Common Errors Seen in Plan Review

Melissa Effinger, P.E. – Michael Baker Intl.

Rebecca Camarata, P.E. – INDOT

GRADING DETAIL FOR GUARDRAIL END TREATMENT TYPE OS

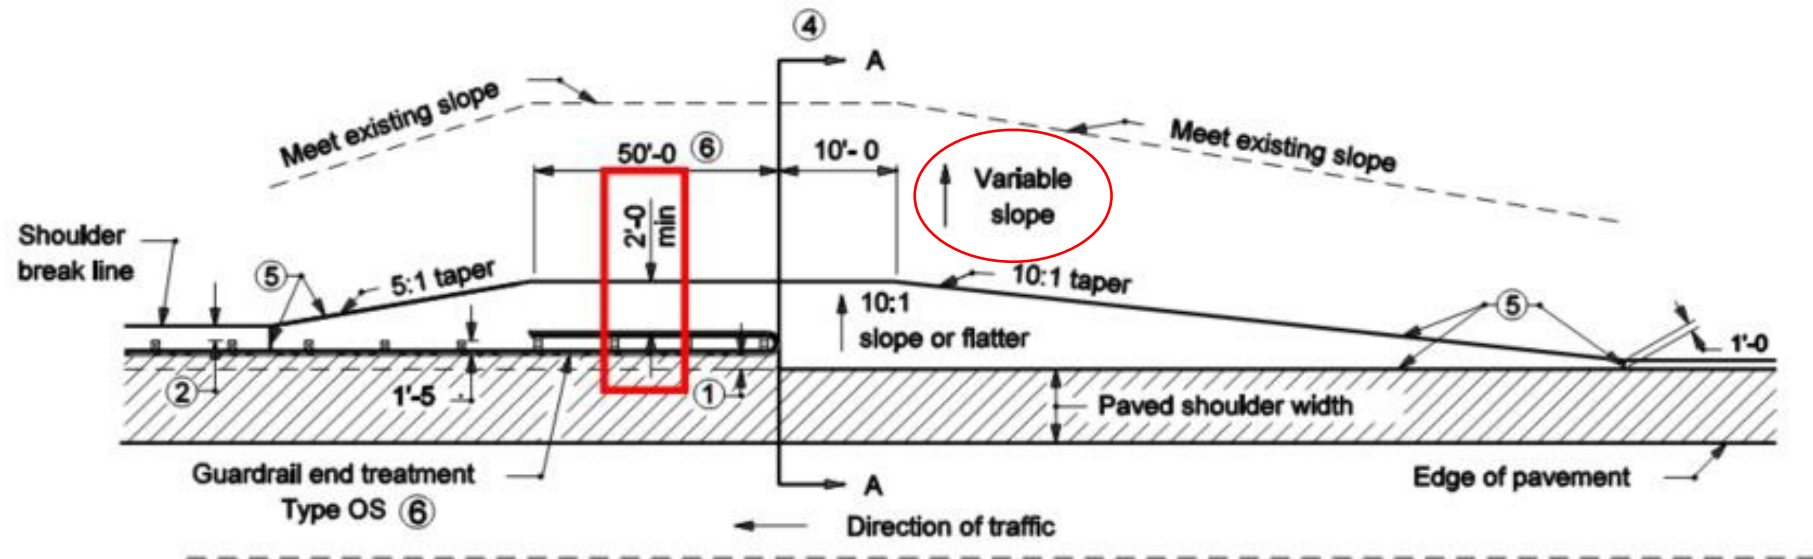
- Not providing the required grading behind a GRET OS.
- The minimum 2 ft distance at 10:1 or flatter slope is required, not desirable
- The allowable variable slopes beyond this distance are shown on Std. Dwg. 601-GRET-08 and 09

TYPICAL MGS W-BEAM INSTALLATION AT CURB

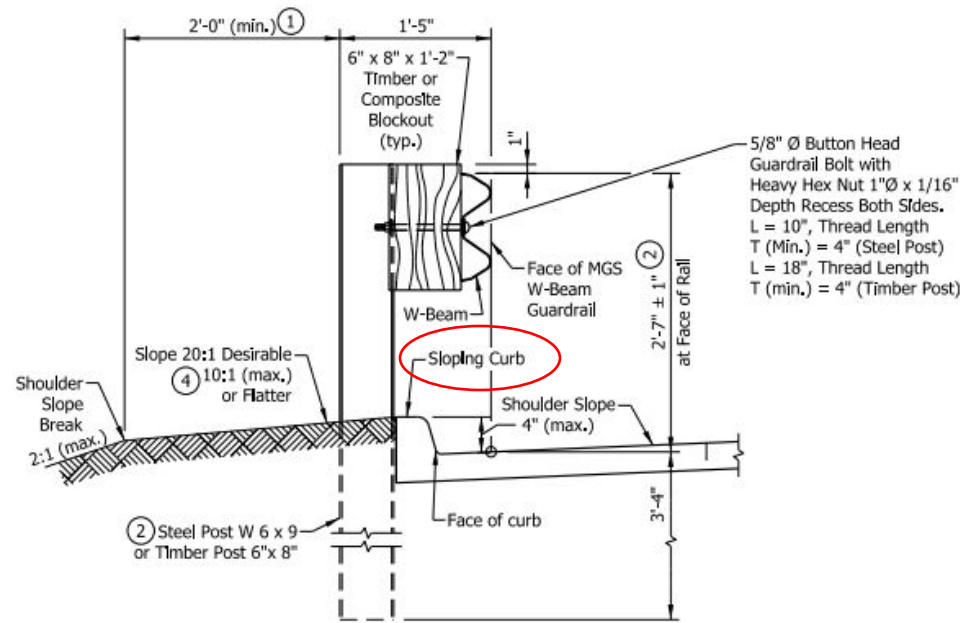
- MGS Guardrail
 - Specifying barrier curb with guardrail or placing curb (of any kind) in front of the face of guardrail.
 - Refer to Design Memos 17-10 and 17-17. IDM Ch. 49 has not yet been updated

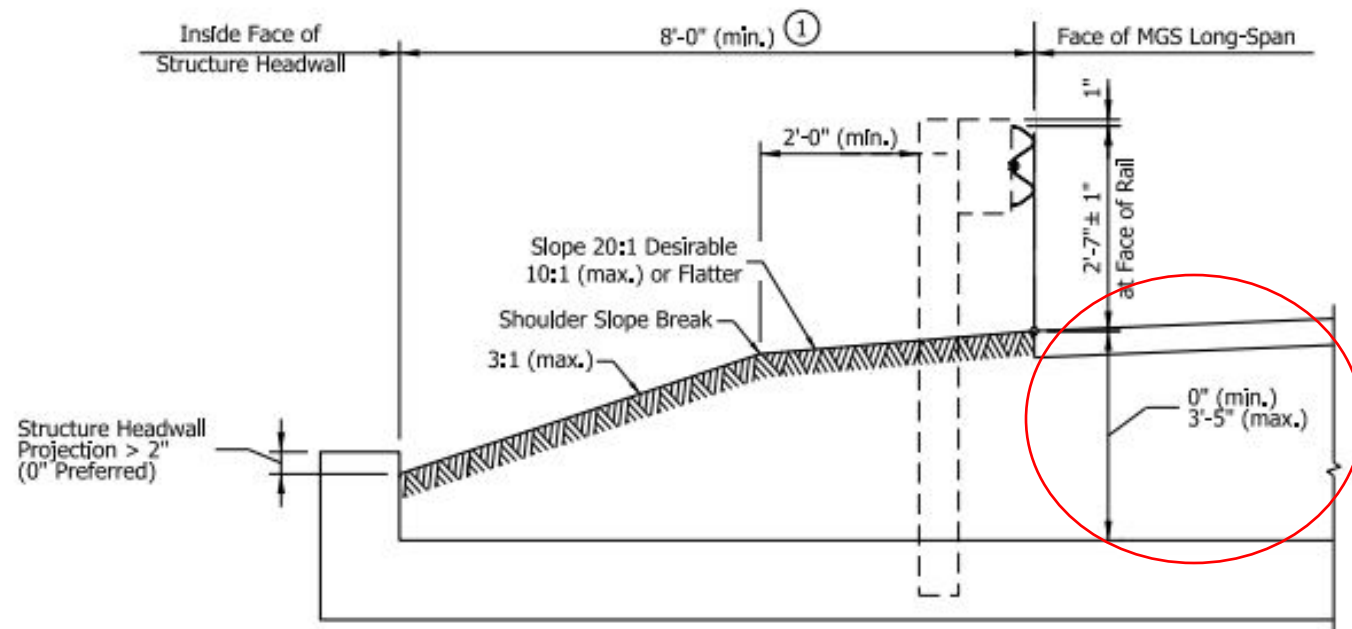
- Placing standard MGS Guardrail over a culvert without sufficient cover for the 3'-4" post lengths.

- Omit one post (max. out to out structure width is 16'-3")
- Use long span section (max. out to out structure width is 22'-6")
- Specify top-mounted posts

• Don't forget to check working width for any of these options.

INDIANA DEPARTMENT OF TRANSPORTATION	
MIDWEST GUARDRAIL SYSTEM ASSEMBLY, LONG-SPAN	
SEPTEMBER 2018	
STANDARD DRAWING NO.	E 601-MGSA-08

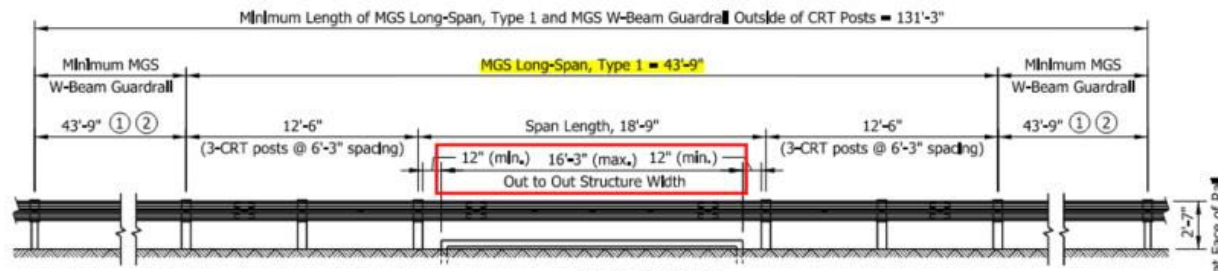
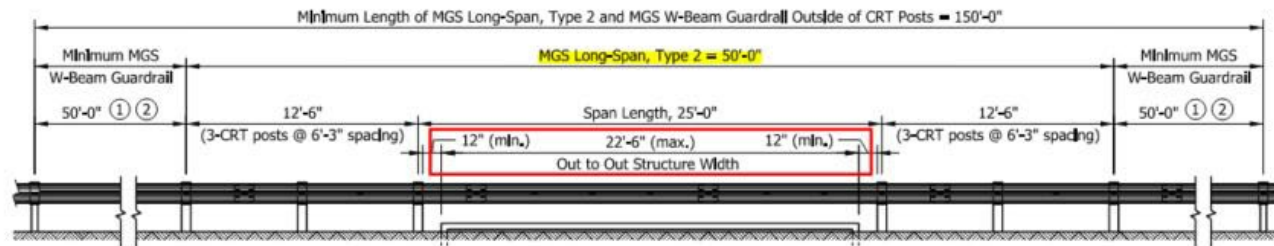
- MGS Guardrail over low fill structures
 - Placing an MGS Long Span section without sufficient lateral clearance between the posts and structure.

- Follow guidance on maximum out to out structure width. Don't forget to account for a skew.
- If a structure's out to out width exceeds 22'-6", then Top-Mounted Posts can be used. See 601-MGSA-10

STANDARD DRAWING NO. E 601-CWGS-02

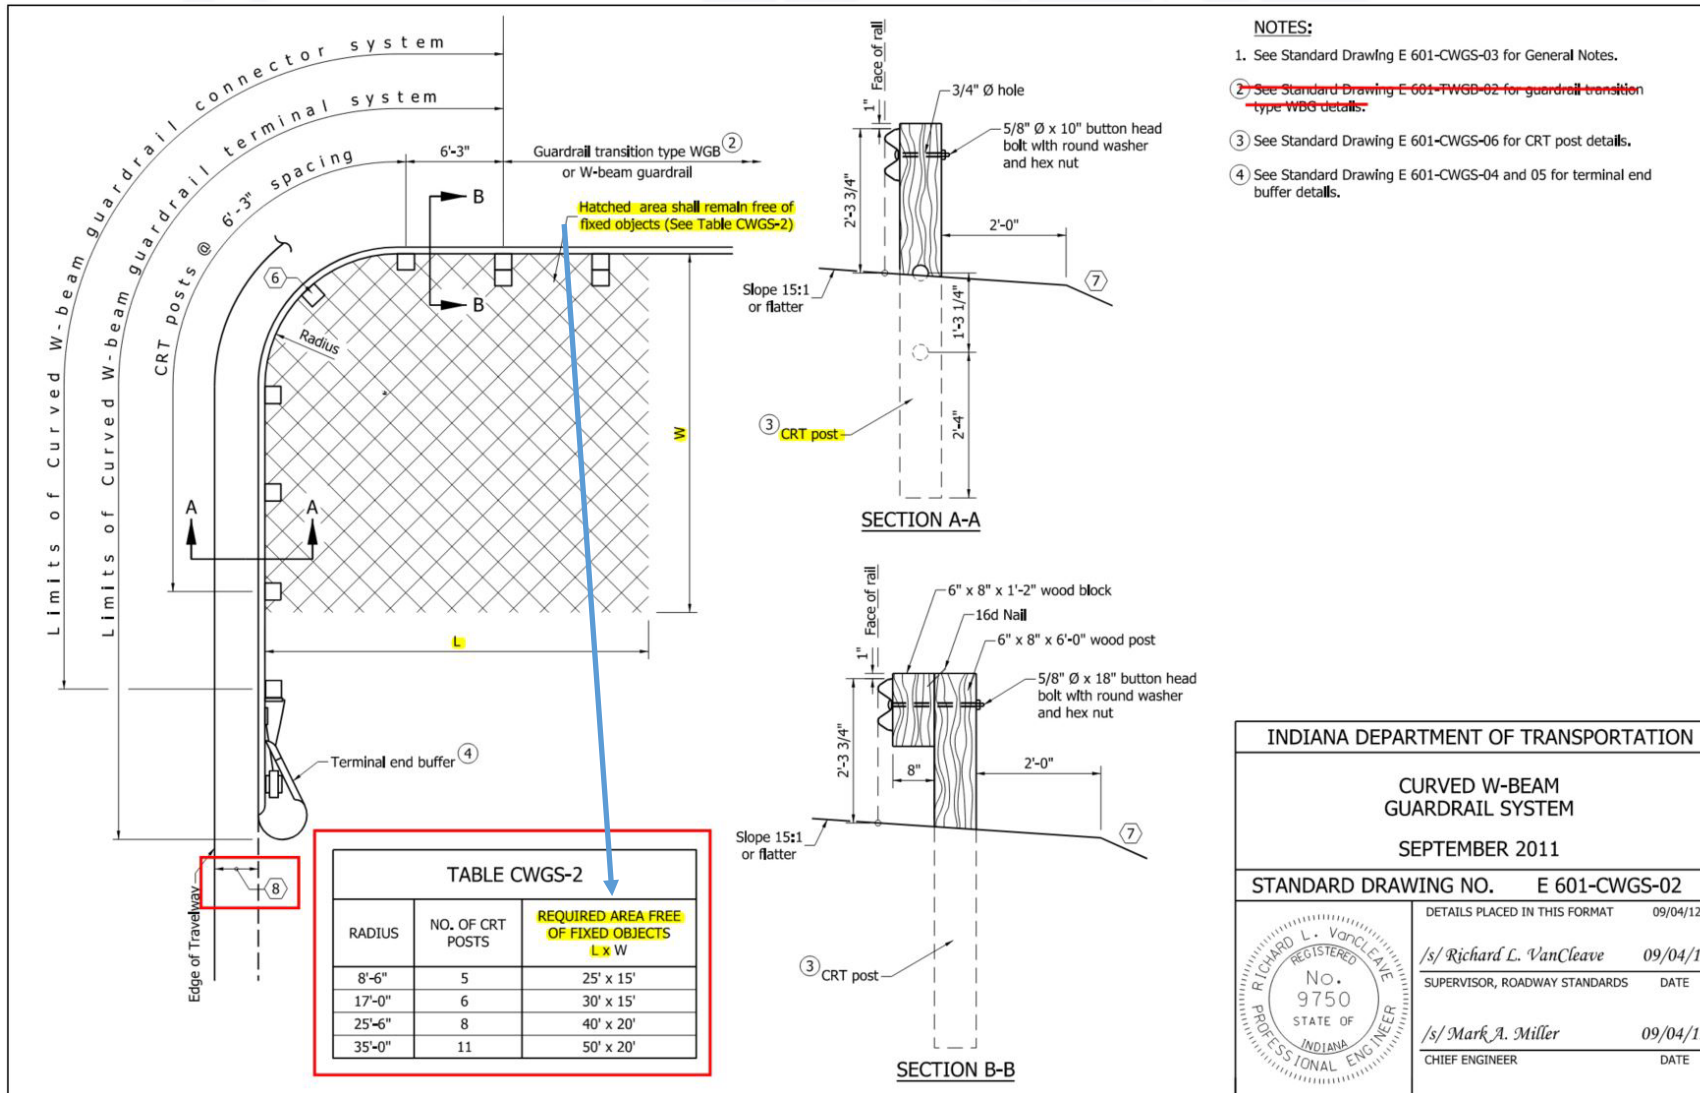
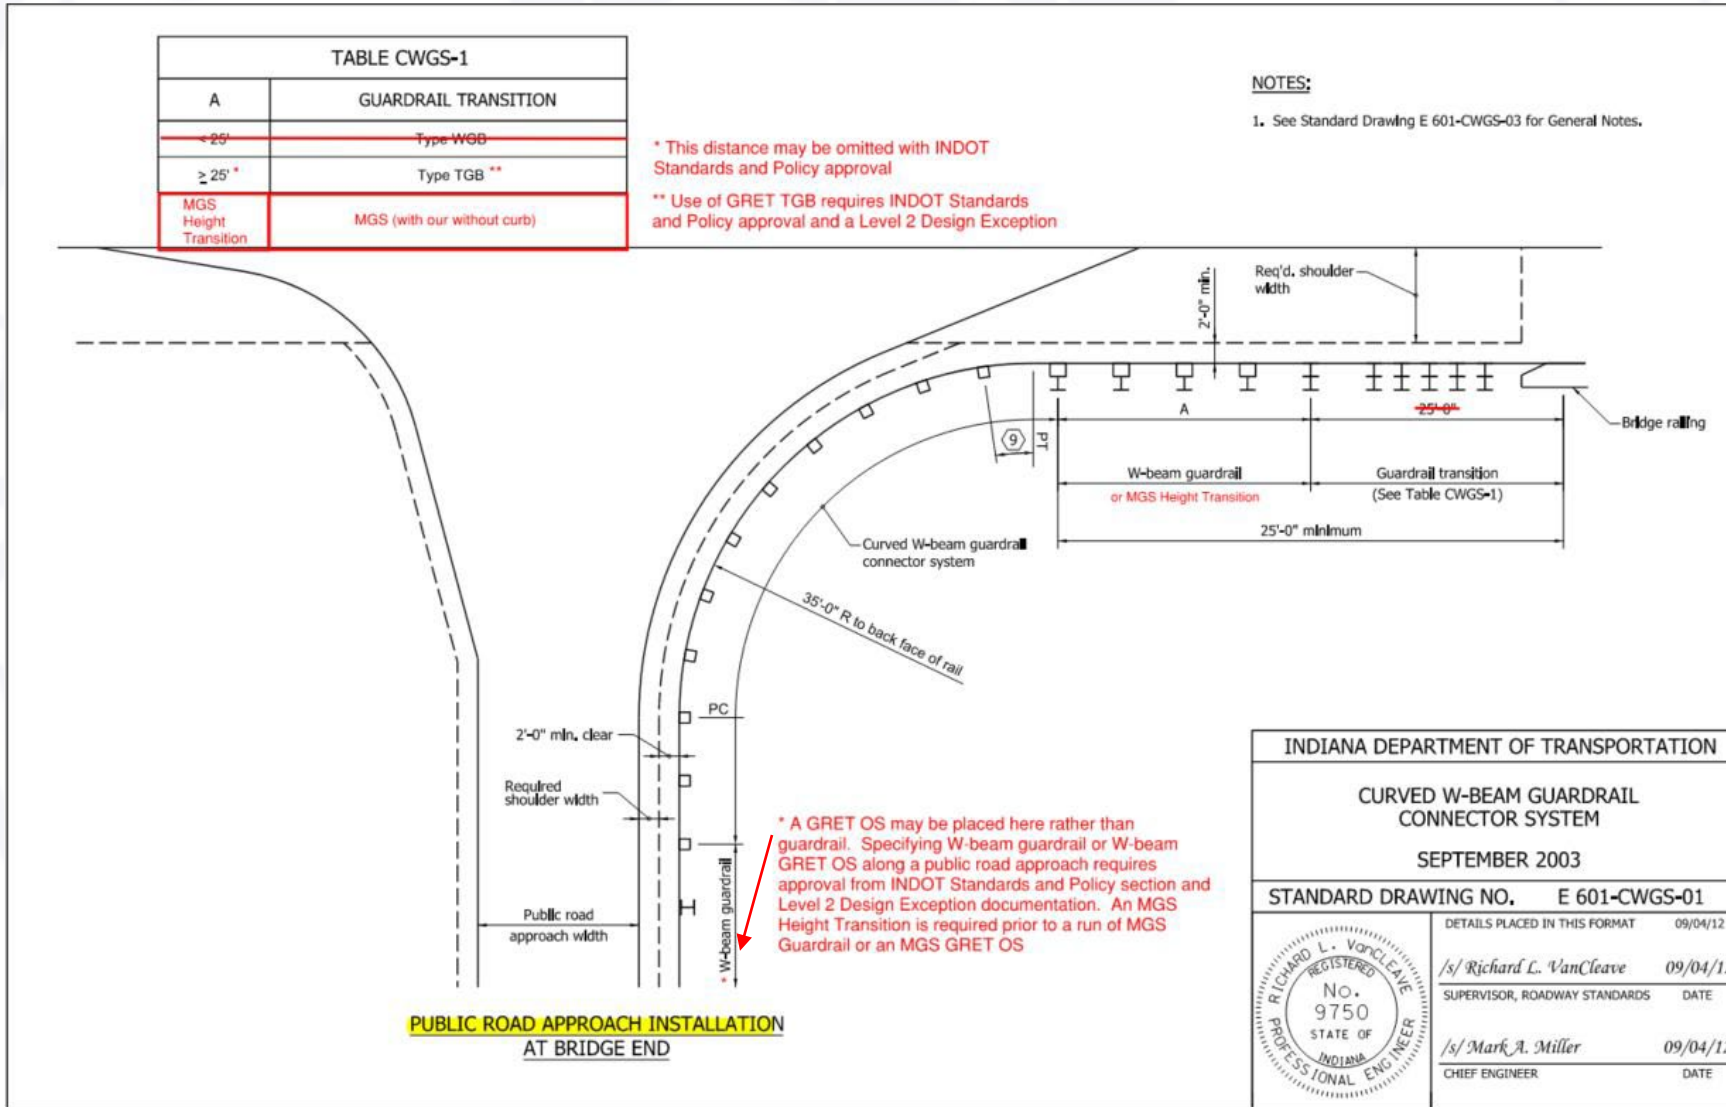
- Curved W-Beam Guardrail Connector and Terminal Systems
 - **Incorrect layout for Curved W-Beam Guardrail and Connector Systems**
 - An MGS height transition is required when connecting MGS Guardrail to either of the W-beam curved sections – MGS curved sections are under development (national effort, every DOT is looking at it).

- Ensure hatched area shown on the Std. Dwg. 601-CWGS-02 is free of fixed objects.
 - A W-beam connector system can be connected directly to an end treatment, but a height transition is needed when specifying the taller GRET OS. The MGS height transition can replace the min 25' of guardrail shown on Std. Dwg. E 601-CWGS-01.

From Std. Dwg. 601-RHPG-02

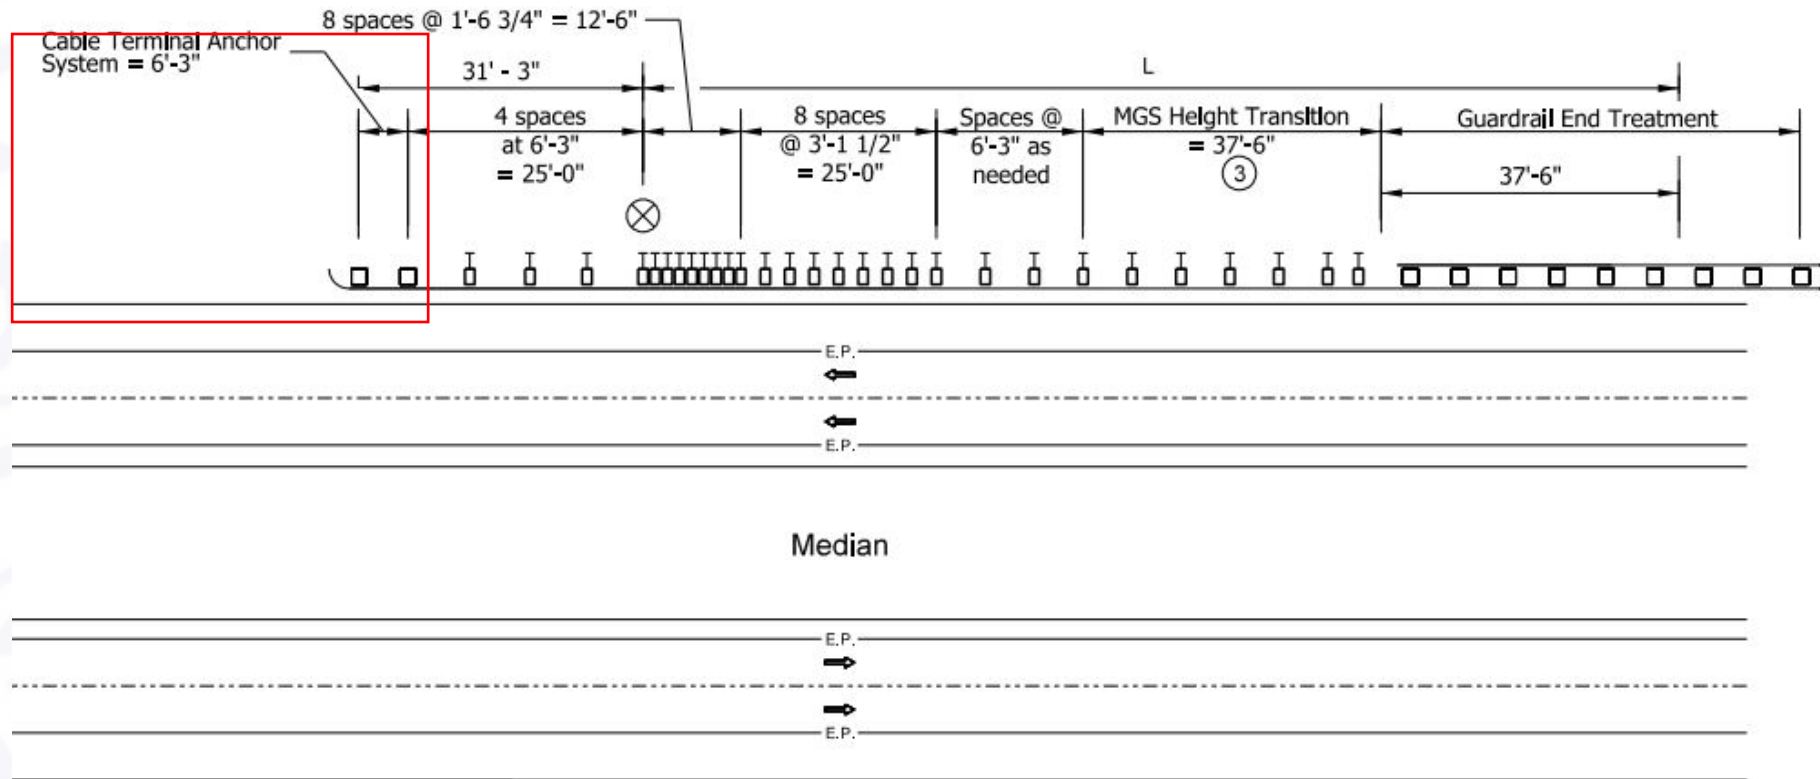
- Guardrail on Divided Highways
 - Not providing an MGS Cable Terminal Anchor at the outgoing end of MGS Guardrail on a divided highway application.

Figure 49-4J

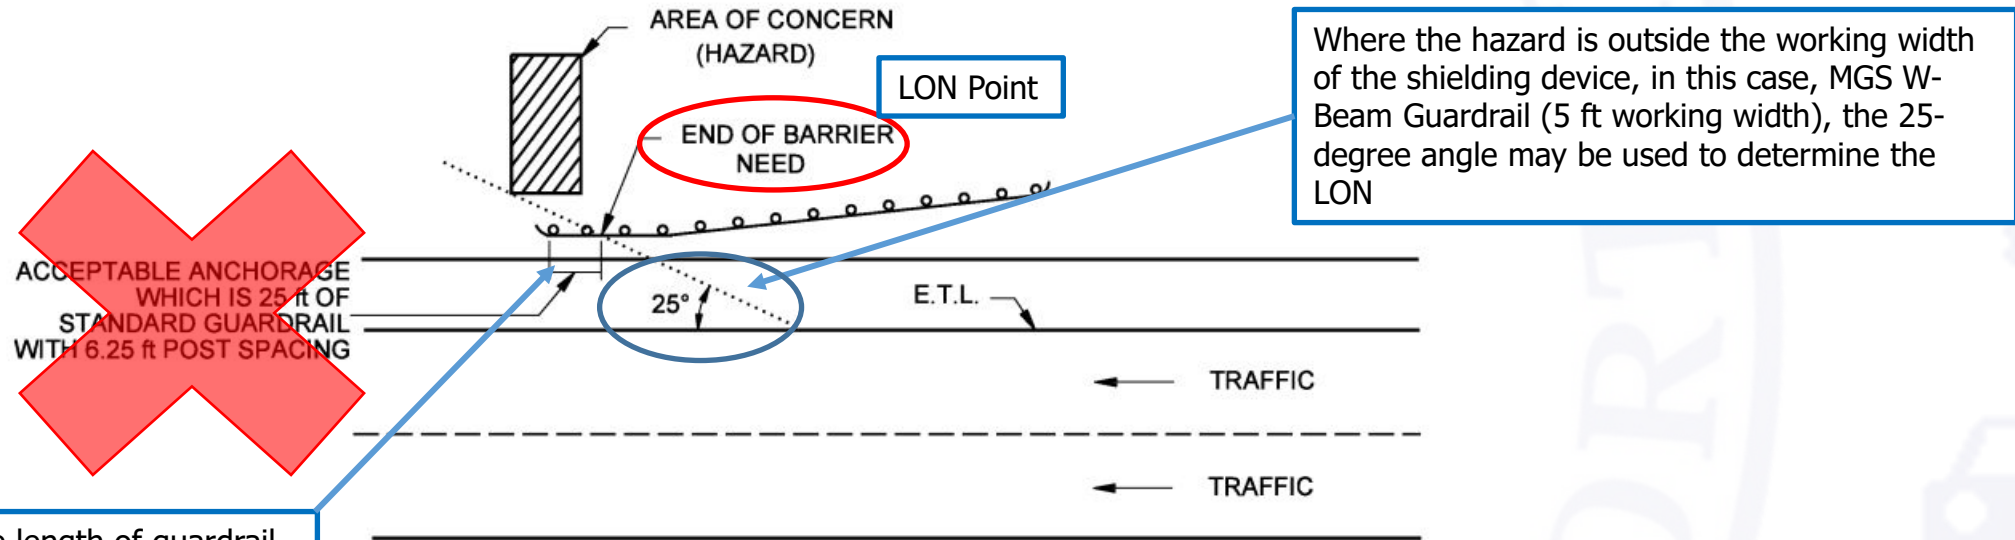
- Length of Need (LON) Calculation beyond Hazard Outside of the Working Width

The length of guardrail beyond the LON should be set per Design Memo 17-10 and should equal 31'-3" which includes the length of the MGS W-Beam Cable Terminal Anchor
